Access Audit Site Report

Inks Lake State Park

Accessibility Evaluation

Inspection Date: 08/23/2021

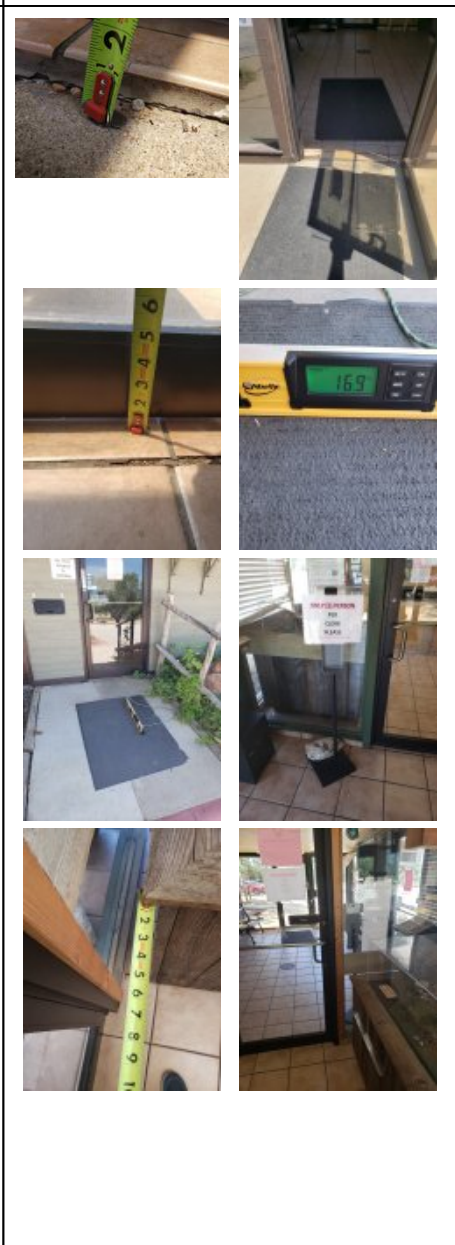
3	Headquarters: Headquarters Parking	[30.7372593 , -98.369303 6]	The cross slopes (narrow dimension) and/or running slopes (long dimension) of the access aisle exceeds 2%. The running slope and the cross slope in an accessible parking stall and the access aisle must not exceed 2%.	access aisle - 4.9% running slope and 4.5% cross slope. stall - 4.4% running slope and 6.1% cross slope	Repair or correct slope of parking space and access aisle to max 2.08% in any direction	2015 ABAAS Section: 502.4 2012 TAS Section: 502.4 2010 ADAS Section: 502.4

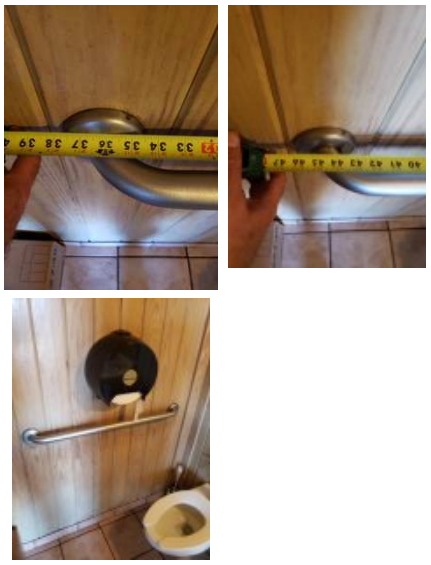
Finding Number	Area Description	Lat/Long	Finding	As Built	Recommendation	Citation	Photos	Figure
10	Headquarters: Headquarters Public Spaces	[30.73737, -98.36903]	The bench is not accessible because there is no clear floor space for either a forward or side approach. The clear floor or ground space shall be 30 inches minimum by 48 inches minimum.	CFS for bench reduced by entry door	Provide required 30" by 48" CFS at bench	2015 ABAAS Section: 305.3 2012 TAS Section: 305.3 2010 ADAS Section: 305.3		
11	Headquarters: Headquarters Public Spaces	[30.73737, -98.36903]	There is no accessible route to the Gibbs Family Picnic Area. At least one accessible route shall connect accessible buildings, accessible facilities, accessible elements, and accessible spaces that are on the same site.	no AR to Gibbs Family Picnic Area (4 benches 2 picnic tables)	Create an accessible route with crushed stone or other outdoor material from parking or walkway to Gibbs Family Picnic Area.	2015 ABAAS Section: F206.2.2 2012 TAS Section: 206.2.2 2010 ADAS Section: 206.2.2

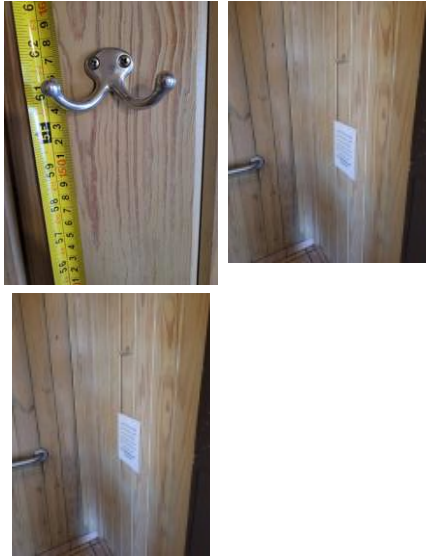
Finding Number	Area Description	Lat/Long	Finding	As Built	Recommendation	Citation	Photos	Figure
15	Headquarters: Headquarters Public Spaces	[30.73737, -98.36903]	There is no accessible route to headquarter amenities. At least one accessible route shall connect accessible buildings, accessible facilities, accessible elements, and accessible spaces that are on the same site.	picnic table, trash, cigarette trash, and recycle bin are not on AR	Create an accessible route with crushed stone or other outdoor material from parking or walkway to headquarter amenities.	2015 ABAAS Section: F206.2.2 2012 TAS Section: 206.2.2 2010 ADAS Section: 206.2.2		
16	Headquarters: Headquarters Restrooms	[30.73737, -98.36903]	The restroom sign does not comply with one or more applicable requirements for the location, height, and properties of the sign.	employee restroom - 61" on door, non compliant sign, lacks International Symbol of Accessibility (ISA)	Acquire and mount signage, including Braille and access symbol mounted on wall, latch side of door, 48" to baseline of lowest character and 60" to baseline of highest character	2015 ABAAS Section: F216.2, 703.1, 703.2, 703.5, 703.6 2012 TAS Section: 216.2, 703.1, 703.2, 703.5, 703.6 2010 ADAS Section: 216.2, 703.1, 703.2, 703.5, 703.6

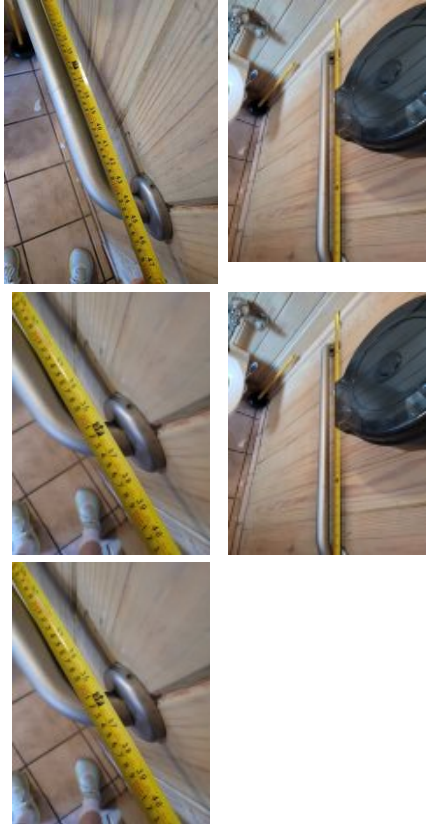
19	Headquarters: Headquarters Restrooms	[30.73737, -98.36903]	The required 56 inches by 60 inches clear floor space for the water closet has been obstructed. The clear floor space around the water closet shall be 60 inches minimum measured perpendicular from the side wall and 56 inches minimum measured perpendicular from the rear wall.	employee restroom - sink and trash in clearance	Relocate trash bin to provide required 60" clearance around toilet. Leave as is sink, meets safe harbor.	2015 ABAAS Section: 604.3. 2012 TAS Section: 604.3.1 2010 ADAS Section: 604.3.1

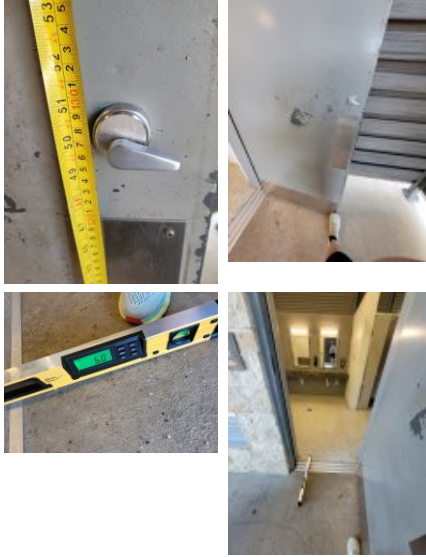
33	Headquarters: Headquarters Restrooms	[30.73737, -98.36903]	The rear grab bar is missing. Grab bars shall be installed in a horizontal position, 33 inches minimum and 36 inches maximum above the finish floor measured to the top of the gripping surface and the space between the grab bar and the top of the tank (any obstruction) shall be 1-1/2 inches minimum.	public restroom - missing rear grab bar	Install rear grab bar with one 36" long, mounted behind the toilet, 12" to one side of center and 24" to the other and 33" to 36" aff	2015 ABAAS Section: 609.4 2012 TAS Section: 609.4 2010 ADAS Section: 609.4

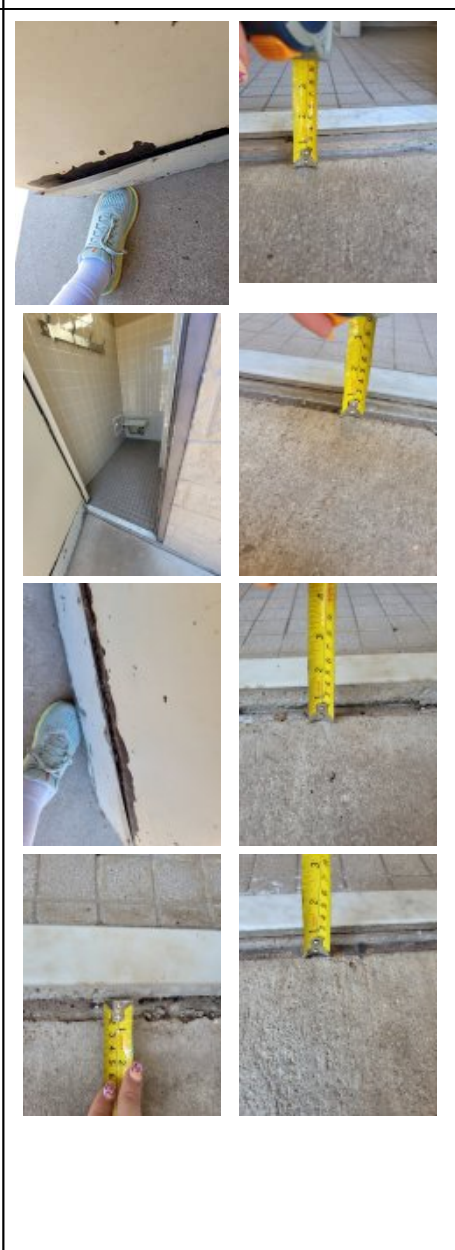
59	Restrooms For Camping: Restroom 2	[30.73737, -98.36903]	The accessible toilet compartment does not provide proper toe clearance on the front and/or side partition. The front partition and at least one side partition shall provide a toe clearance of 9 inches minimum above the finish floor and 6 inches deep minimum beyond the compartment-side face of the partition, exclusive of partition support members. Toe clearance at the side partition is not required in a compartment greater than 66 inches wide. Toe clearance at the front partition is not required where the depth is minimum 62 inches for a wall hung toilet and minimum 65 inches for a floor mounted toilet.	women's - no toe clearance	Provide toe clearance at the front and side partitions, or enlarge stall to provide the same	2015 ABAAS Section: 604.8.1.4 2012 TAS Section: 604.8.1.4 2010 ADAS Section: 604.8.1.4

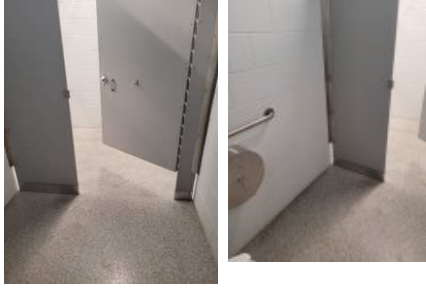
Finding Number	Area Description	Lat/Long	Finding	As Built	Recommendation	Citation	Photos	Figure
98	Restrooms For Camping: Restroom 4 (Central Park)	[30.73737, -98.36903]	Employee Work Areas. Common use circulation paths within employee work areas shall comply with 402. EXCEPTIONS: 1. Common use circulation paths located within employee work areas that are less than 1000 square feet (93 m2) and defined by permanently installed partitions, counters, casework, or furnishings shall not be required to comply with 402. 2. Common use circulation paths located within employee work areas that are an integral component of work area equipment shall not be required to comply with 402. 3. Common use circulation paths located within exterior employee work areas that are fully exposed to the weather shall not be required to comply with 402.	concessions - no route	Make corrections for compliant circulation path.	2015 ABAAS Section: F206.2.8, F206.2.8.1, F206.2.8.2 2012 TAS Section: 206.2.8, 206.2.8 Exception 1, 206.2.8 Exception 2, 206.2.8 Exception 3, 206.2.8 Advisory 1, 206.2.8 Advisory 2 2010 ADAS Section: 206.2.8, 206.2.8 Exception 1, 206.2.8 Exception 2, 206.2.8 Exception 3

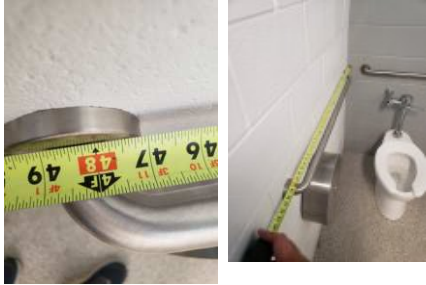
Finding Number	Area Description	Lat/Long	Finding	As Built	Recommendation	Citation	Photos	Figure
104	Restrooms For Camping: Restroom 4 (Central Park)	[30.73737, -98.36903]	The toilet is not located within the range allowed from the side wall or partition. The centerline of the toilet must be 16 to 18 inches from the side wall.	women's - 22" to centerline	Remount toilets to 16" to 18" from the side wall to centerline	2015 ABAAS Section: 604.2 2012 TAS Section: 604.2 2010 ADAS Section: 604.2		
105	Restrooms For Camping: Restroom 4 (Central Park)	[30.73737, -98.36903]	The stall door fails to comply with all of the door requirements. The stall door must be a minimum of 32" wide and have compliant hardware on both sides. The stall door must be self-closing.	women's - stall door not self closing	Adjust stall door to be self-closing	2015 ABAAS Section: 404.2.3, 404.2.7, 604.8.2.2 2012 TAS Section: 404.2.3, 404.2.7, 604.8.2.2 2010 ADAS Section: 404.2.3, 404.2.7, 604.8.2.2

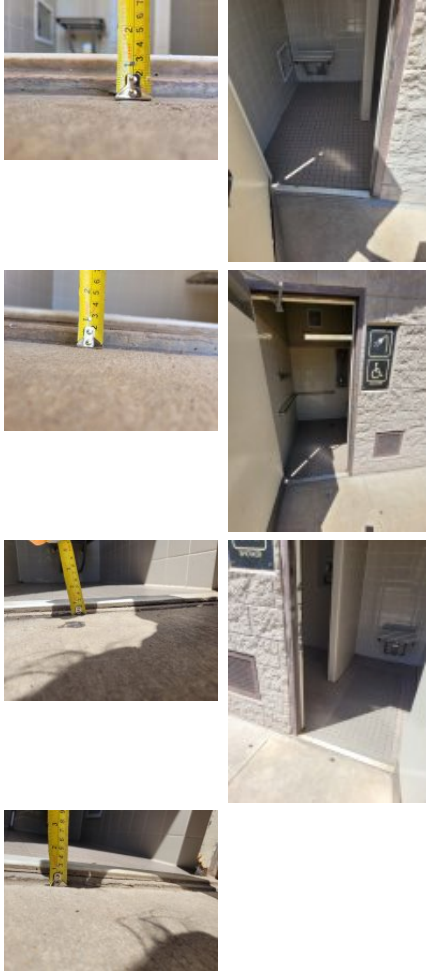
112	Restrooms For Camping: Restroom 5	[30.73737, -98.36903]	The operable part is not accessible because there is not adequate clear floor space for either a forward or side approach. The clear floor or ground space shall be 30 inches minimum by 48 inches minimum.	women's - CFS for built in baby changer reduced by accessible shower	Provide required 30" by 48" CFS at operable parts	2015 ABAAS Section: 305.3 2012 TAS Section: 305.3 2010 ADAS Section: 305.3		
113	Restrooms For Camping: Restroom 5	[30.73737, -98.36903]	The accessible toilet compartment does not provide proper toe clearance on the front and/or side partition. The front partition and at least one side partition shall provide a toe clearance of 9 inches minimum above the finish floor and 6 inches deep minimum beyond the compartment-side face of the partition, exclusive of partition support members. Toe clearance at the side partition is not required in a compartment greater than 66 inches wide. Toe clearance at the front partition is not required where the depth is minimum 62 inches for a wall hung toilet and minimum 65 inches for a floor mounted toilet.	women - no toe clearance, 60 depth	Provide toe clearance at the front and side partitions, or enlarge stall to provide the same	2015 ABAAS Section: 604.8.1.4 2012 TAS Section: 604.8.1.4 2010 ADAS Section: 604.8.1.4

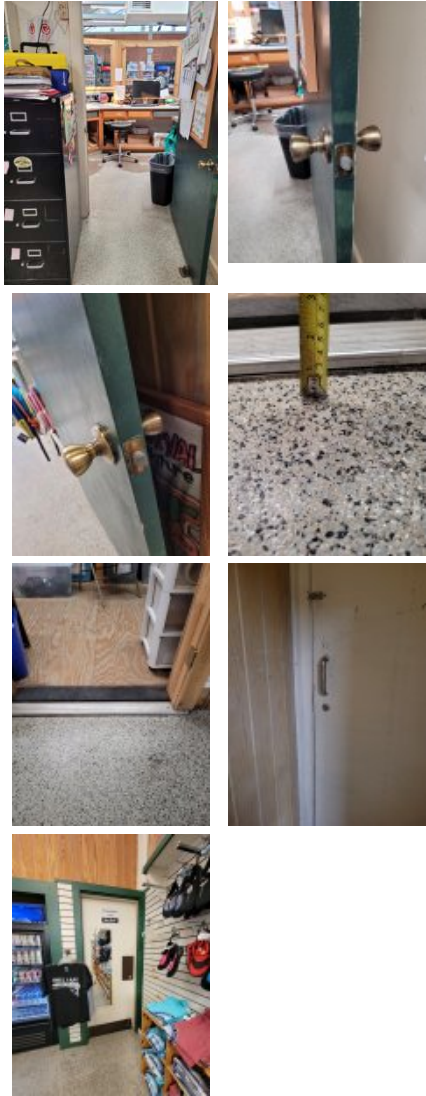
Finding Number	Area Description	Lat/Long	Finding	As Built	Recommendation	Citation	Photos	Figure
177	Park Store: Park Store Parking	[30.7423565, -98.3673778]	The parking sign is mounted too low. Parking space identification signs shall include the International Symbol of Accessibility complying with. Signs identifying van parking spaces shall contain the designation "van accessible." Signs shall be 60 inches minimum above the finish floor or ground surface measured to the bottom of the sign.	40" above ground level (agl)	Raise existing accessible parking signs so lowest end of bottom sign is min 60" agl	2015 ABAAS Section: 502.6 2012 TAS Section: 502.6 2010 ADAS Section: 502.6	 	
178	Park Store: Park Store Parking	[30.73737, -98.36903]	Element meets all standards and requirements	5 standard stalls, 1 accessible	None	2010 ADAS Section: N/A

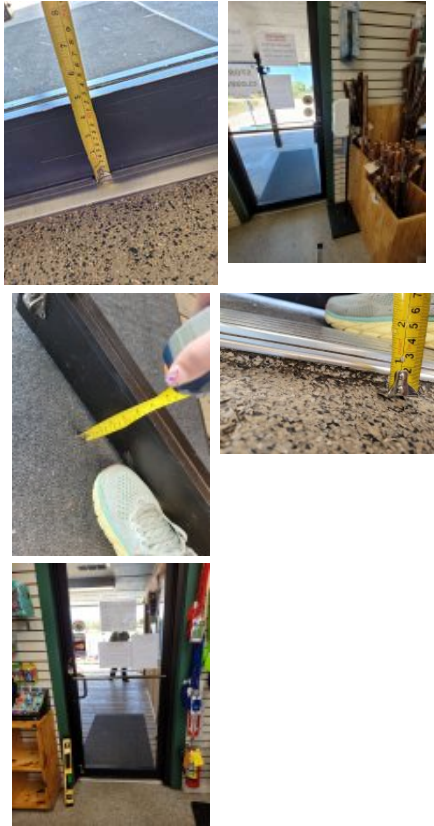
Finding Number	Area Description	Lat/Long	Finding	As Built	Recommendation	Citation	Photos	Figure
191	Park Store: Park Store Employee Spaces	[30.73737, -98.36903]	The restroom sign does not comply with one or more applicable requirements for the location, height, and properties of the sign.	no signage indicating restroom	Acquire and mount signage, including Braille and access symbol mounted on wall, latch side of door, 48" to baseline of lowest character and 60" to baseline of highest character	2015 ABAAS Section: F216.2, 703.1, 703.2, 703.5, 703.6 2012 TAS Section: 216.2, 703.1, 703.2, 703.5, 703.6 2010 ADAS Section: 216.2, 703.1, 703.2, 703.5, 703.6		
192	Park Store: Park Store Employee Spaces	[30.73737, -98.36903]	Knee clearance at 27 inches off the floor is not 8 inches minimum deep. The knee clearance, measured from the bottom of the apron or the outside bottom edge of the lavatory, must be 27 inches at a point located 8 inches back from the front edge and continuing to 11 inches minimum in depth at 9 inches above the floor. The top of the lavatory rim may be no higher than 34 inches.	knee clearance reduced by storage	Relocate storage to provide 27" knee clearance that is a min 8" deep	2015 ABAAS Section: 306.3.1, 306.3.2, 306.3.3, 306.3.4, 306.3.5 2012 TAS Section: 306.3.2, 306.3.3, 306.3.4, 306.3.5, 306.3.1 2010 ADAS Section: 306.3.3, 306.3.2, 306.3.4, 306.3.5, 306.3.1

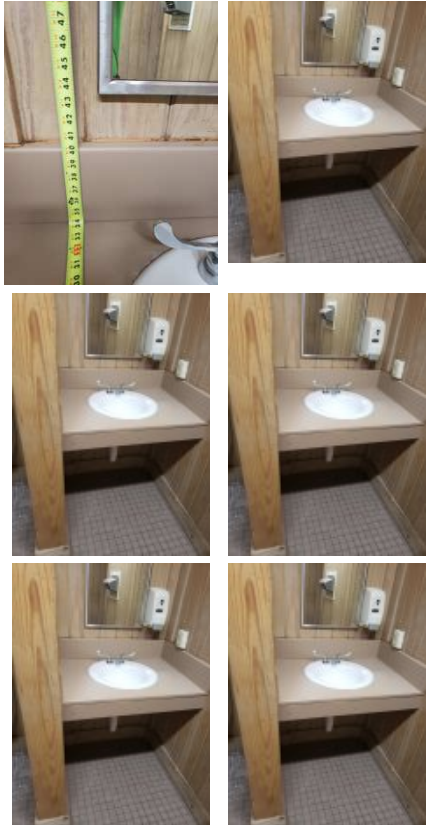
Finding Number	Area Description	Lat/Long	Finding	As Built	Recommendation	Citation	Photos	Figure
195	Park Store: Park Store Employee Spaces	[30.73737, -98.36903]	The operable part is not accessible because there is not adequate clear floor space for either a forward or side approach. The clear floor or ground space shall be 30 inches minimum by 48 inches minimum.	no CFS to hooks, hand dryers, or plug due to storage	Remove, or relocate storage in CFS at fixtures and operable parts along the AR	2015 ABAAS Section: 305.3 2012 TAS Section: 305.3 2010 ADAS Section: 305.3		
196	Park Store: Park Store Employee Spaces	[30.73737, -98.36903]	The required 56 inches by 60 inches clear floor space for the water closet has been obstructed. The clear floor space around the water closet shall be 60 inches minimum measured perpendicular from the side wall and 56 inches minimum measured perpendicular from the rear wall.	amb stall provided in single user restroom	Eliminate ambulatory stall and relocate storage to provide required 60" clearance around toilet	2015 ABAAS Section: 604.3. 2012 TAS Section: 604.3.1 2010 ADAS Section: 604.3.1

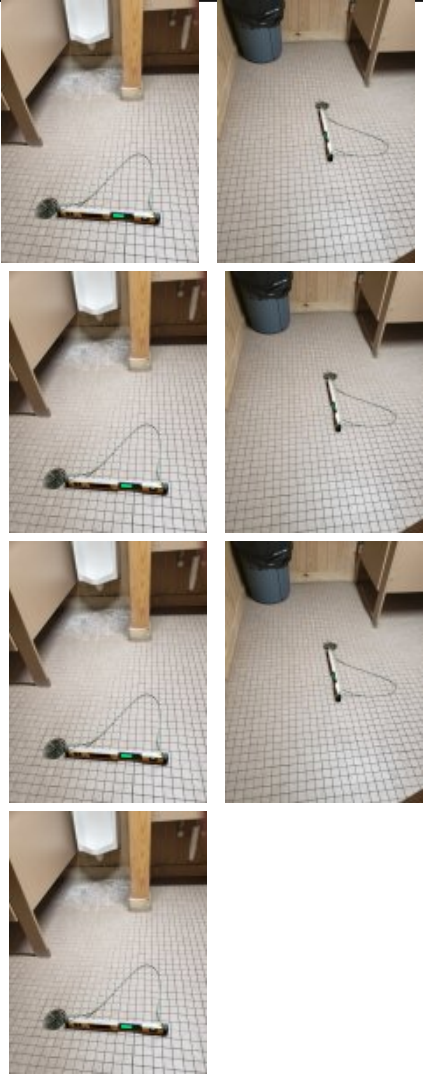
Finding Number	Area Description	Lat/Long	Finding	As Built	Recommendation	Citation	Photos	Figure
205	Park Store: Park Store Public Spaces	[30.73737, -98.36903]	Minimum maneuvering clearances at doors and gates shall comply with 404.2.4. Maneuvering clearances shall extend the full width of the doorway and the required latch side or hinge side clearance. The threshold has a vertical change greater than 1/4 inch high. The threshold at a doorway shall be no higher than 1/2 inch. Changes in level between 1/4 inch and 1/2 inch must be beveled at 1:2 or less. 1/4 inch is the maximum vertical rise. Exterior doors are recommended to be maintained at 8.5 lbf as a smart practice. Force is to be measured at the operating hardware or 30 inches from the hinges, whichever is greater. The bottom 10 inches on the push side must be smooth and free of obstructions (hold open devices). Opening hardware must be mounted between 30 and 44 inches above the floor or ground.	door to entry from lot - 5" at bottom, MC on push reduced by items. back door - 5" at bottom, 10# push, 1" CIL	For all doors along the public circulation route, provide required maneuvering clearance on push and pull side of doors For all doors along the public circulation route, repair, bevel, or ramp CILs at door entries to max .25" For all doors along the public circulation route, inspect, adjust, and maintain 8.5 lbf to open exterior doors as a smart practice For all doors along the public circulation route, provide kick plate on push side of door from floor to 10" aff	2010 ADAS Section: 404.2.3, 404.2.7, 404.2.4, 404.2.11, 404.2.11 Exception	 <p>The photos show various views of door thresholds and interiors. Top-left: A yellow measuring tape is held vertically against a dark door threshold on a speckled floor. Top-right: An interior view of a doorway with a kick plate and a yellow measuring tape. Middle-left: A close-up of a hand holding a yellow measuring tape against a dark door threshold. Middle-right: A close-up of a yellow measuring tape against a door threshold. Bottom: A wider interior view of a doorway with a kick plate and a yellow measuring tape.</p>

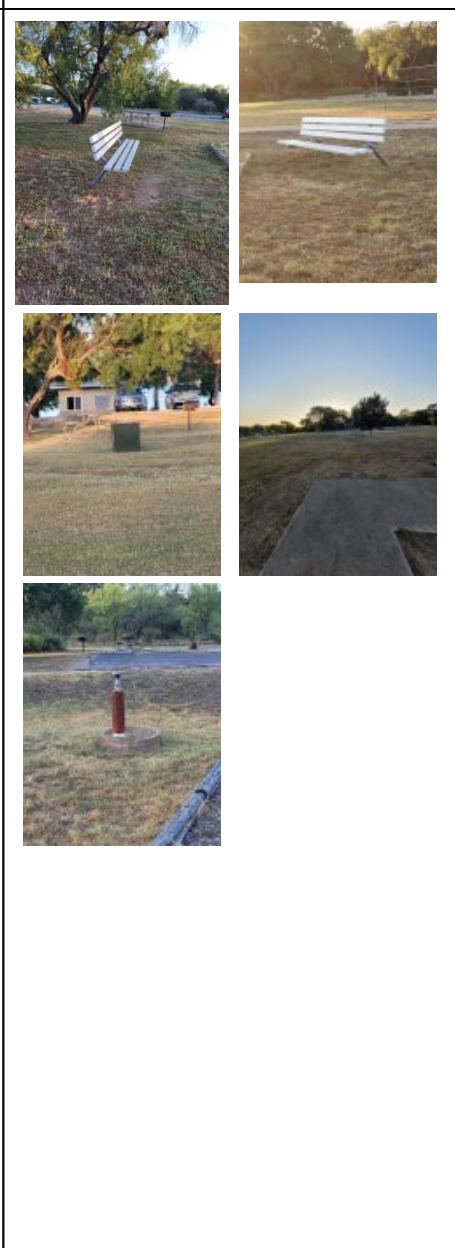
228	Park Amenities: Central Park Playground	[30.743078, -98.365725 5]	As a smart practice, play area should have a minimum 60" wide entry, free of changes in level, gaps, and slope.	central park playground - 1.5" CIL at entry to elevated play components (EPCs), 11.2% running slope to EPCs, 1" gap to EPCs, 4" CIL to swings	Repair, bevel or ramp CIL at playground entry/border Correct or repair running slope of designated entry to max 5%	2015 ABAAS Section: F206.1 2012 TAS Section: 206.1 2010 ADAS Section: 206.1

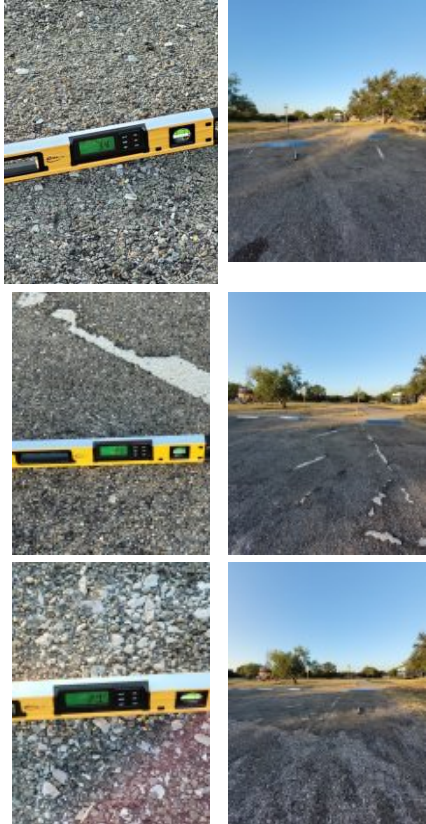
229	Park Amenities: Central Park Playground	[30.7415842 , -98.367153 8]	Play area shall have signage listing designated ages of intended users	central park playground - no signage indicating intended users	Acquire and install intended user signage and mount at designated entry as a smart practice	2015 ABAAS Section: F240.1 2012 TAS Section: 240.1 2010 ADAS Section: 240.1

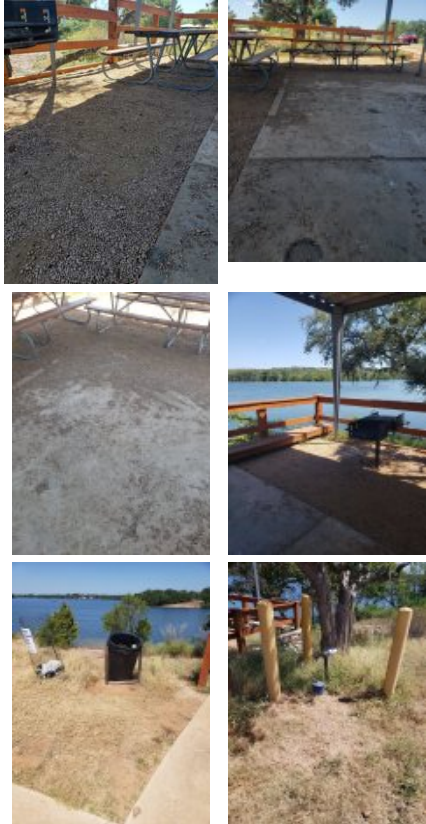
285	Park Amenities: Boat Ramp	[30.7432186 , -98.367466 3]	There is no accessible route to the benches. At least one accessible route shall connect accessible buildings, accessible facilities, accessible elements, and accessible spaces that are on the same site.	no AR to 2 of 2 benches	Create an accessible route with crushed stone or other outdoor material from parking or walkway to benches	2015 ABAAS Section: F206.2.2 2012 TAS Section: 206.2.2 2010 ADAS Section: 206.2.2

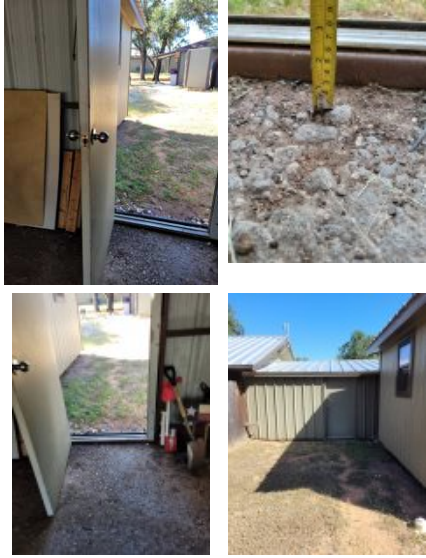
310	Park Amenities: Cabins	[30.73737, -98.36903]	The parking stall contains abrupt edges and surface irregularities over a 1/4 inch vertical. Parking spaces and access aisles serving them shall be stable, firm, and slip resistant. Access aisles shall be at the same level as the parking spaces they serve. Changes in level are not permitted and shall not be sloped steeper than 2% in any direction.	cabin 1 - loose asphalt and gravel	Resurface stalls and access aisles to eliminate gaps and cracks	2015 ABAAS Section: 502.4 2012 TAS Section: 502.4 2010 ADAS Section: 502.4
